UNITED STATES PATENT AND TRADEMARK OFFICE

APPLICATION NO.	FILING DATE	FIRST NAMED INVENTOR	ATTORNEY DOCKET NO.	CONFIRMATION NO.
09/462,994	01/14/2000	UIDO SCHWALKE	P99.2666	5747
7590 11/14/2003				
SCHIFF HARDIN & WHITE PATENT DEPARTMENT 7100 SEARS TOWER CHICAGO, IL 60606-6473				
EXAMINER KEBEDE, BROOK				
ART UNIT 2823 PAPER NUMBER

Office Action Summary	Application No.	Applicant(s)	
	09/462,994	SCHWALKE ET AL. <i>ml</i>	
	Examiner	Art Unit	
	Brook Kebede	2823

DETAILED ACTION

FIG 7

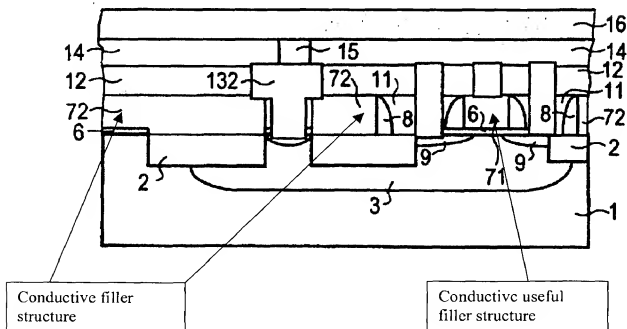
Prior responding applicants' contention that Hirakawa fails to disclose the use of filler structures that perform no circuit-oriented functions, as amended in claim 11, the Examiner respectfully submits the instant application drawing Fig. 7 herein below to show inconsistency between what is being claimed and what is applicants presented to support their argument to show what Hirakawa et al. '508 patent teach or does not teach.

As shown above in Fig. 7, i.e., the instant application drawing, the conductive useful structure **71** formed over the gate oxide film **6**. In the other hand, the conductive filler structure **72** formed on the STI **2** (shallow trench isolation) that is planar with the substrate **1**. As Fig. 7 shows, the conductive filler structure **72** does not have same height as the conductive useful structure **71**. As depicted on Fig. 7, one of ordinary skill in the art will conclude that the height of **72** is not equal to the height of **71**. In contrary applicants assertion, the **height of 72** equals to the **height of 71** plus **height of 6**.

filler structure **72** has different function than form being resistor and conductive useful structure **71** also being gate electrode. What is the “conductive useful structure” mean? What is the “conductive filler structure” mean? Applicants need to clarify this matter because their argument suggest otherwise (see Applicants argument in Pages 10-12) and the whole application may be rejected under 35 U.S.C. 112 first and second Paragraph for lack of enabling disclosure and lack of clarity.

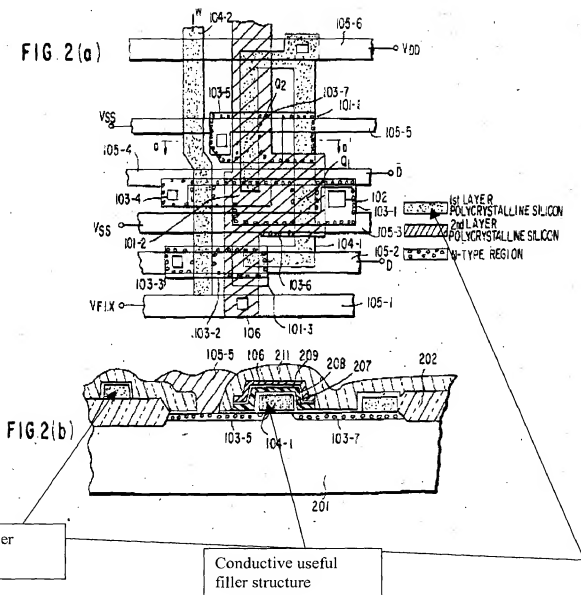
In response to applicants argument that Hirakawa fails to disclose "one conductive filler structure which exhibits essentially the same height, said conductive filler structure having no circuit-oriented function," the Examiner respectfully submits that Hirakawa et al. '508 disclose all the claimed limitations in including the limitation one conductive filler structure which exhibits essentially the same height, said conductive filler structure having no circuit-oriented function. The Examiner respectfully would like to point out to Figs. 2(a) and 2(b) of Hirakawa et al. '508 as shown herein below.

As shown in Fig. 2(a), the first layer polysilicon layer, i.e., the conformal layer used to form the dummy gate (not labeled) (conductive filler structure) and the gate 104-1 (conductive useful structure) basically formed same polysilicon layer which later patterned and they essentially exhibit same height. In addition, the conductive filler

structure, as shown in Figs. 2(a) and 2(b), has no circuit-oriented function. Furthermore, the rejected claim, i.e., claim 11, does not claim that "the conductive useful structures and the conductive filler structure are both formed by applying and structuring a conductive layer which means applying and structuring one and the same conductive layer" as applicants argued. Hence applicants' argument that the references fail to show certain features of applicant's invention, it is noted that the features upon which applicant relies (i.e., the conductive useful structures and the conductive filler structure are both formed by applying and structuring a conductive layer which means applying and structuring one and the same conductive layer) are not recited in the rejected claim(s). Although the claims are interpreted in light of the specification, limitations from the specification are not read into the claims. See *In re Van Geuns*, 988 F.2d 1181, 26 USPQ2d 1057 (Fed. Cir. 1993).
